service bulletin

No. 91.1.002

AIRCRAFT SAAB SAFIR 91A, 91B, 91B-2, 91C AND 91D

SUBJECT: Checking and adjustment of lock pins for front seat buckets.

Figure 1.

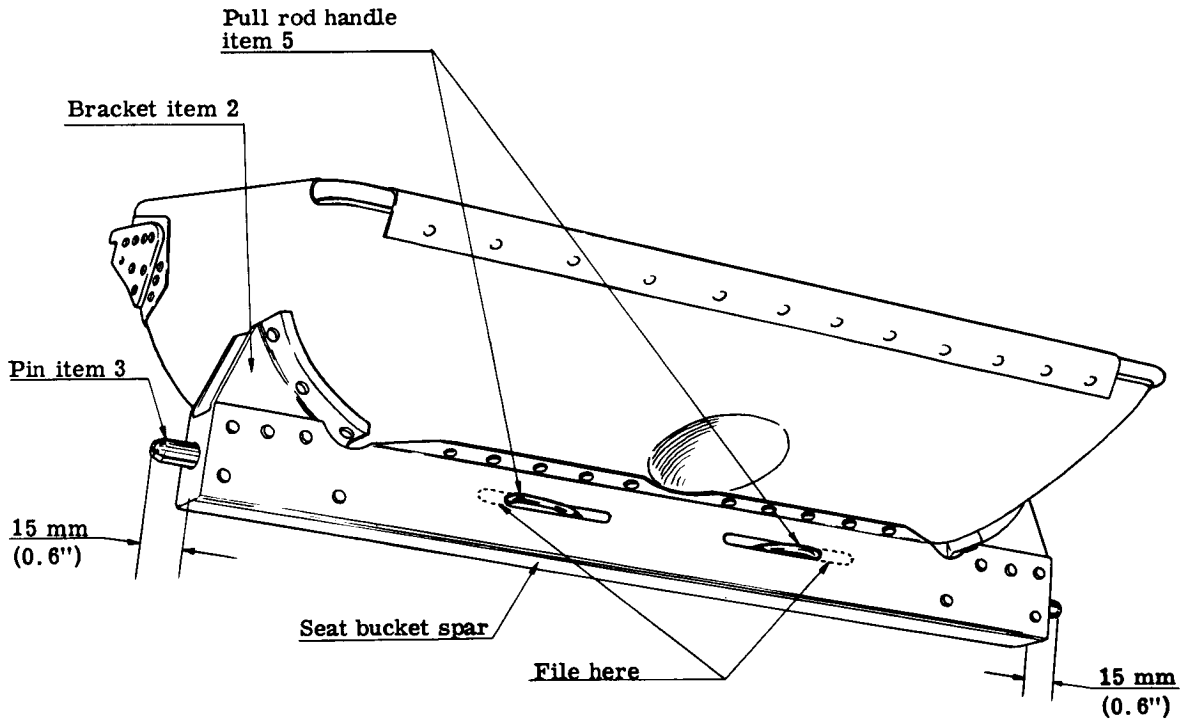
WORK PROCEDURE: Dismount the seat buckets.
Check that pin item 3 protrudes 15 mm (0,6") outside of bracket item 2. If shorter, adjust to minimum 15 mm by extending the slot for pull rod handle item 5 in the seat bucket spar, see figure 1.
Paint a line inside the seat bucket spar corresponding to the position of the pull rod handle when the pin is released, see figure 2. This line will simplify checking of correct seat bucket locking in the aircraft.
